**FORD:**

2011-2014 Mustang

This article supersedes TSB **14-0212** to update the Warranty Basic Part Number and Part List.

Figure 1 - Article 16-0074

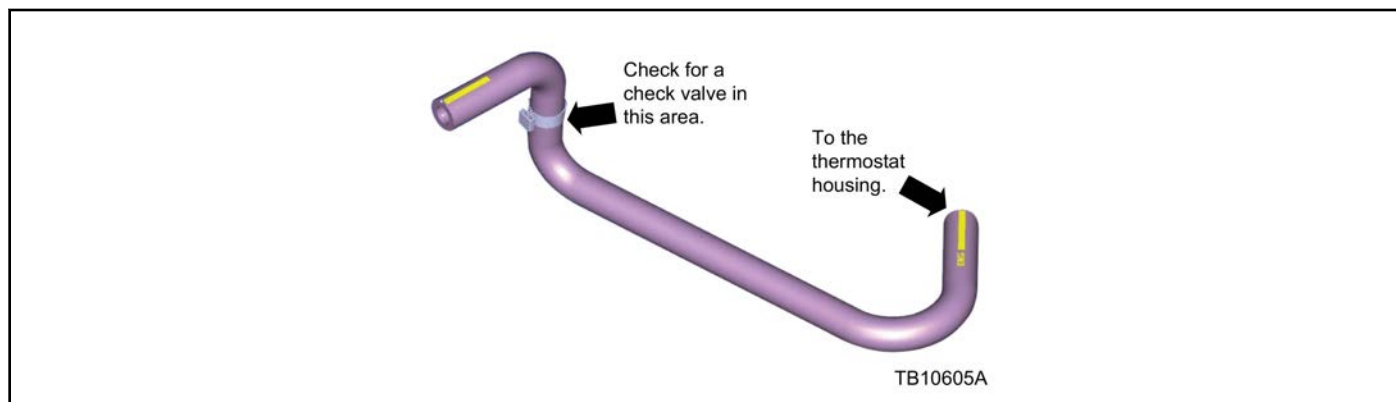
Some 2011-2014 Mustang vehicles equipped with a 3.7L engine may exhibit coolant pump leakage due to air entering the system.

1. Inspect the coolant hose from the thermostat housing to degas bottle. Is the coolant hose equipped with a check valve located as indicated? (Figure 1)

- a. Yes - this article does not apply. Refer to Workshop Manual (WSM), Section 303-03 for normal diagnosis.
  - b. No - replace the coolant pump and coolant hose from the thermostat housing to degas bottle with revised part kit. Refer to WSM, Section 303-03.
- (1) Make sure to orient the new hose properly with the end marked ENG to the thermostat housing. (Figure 1)
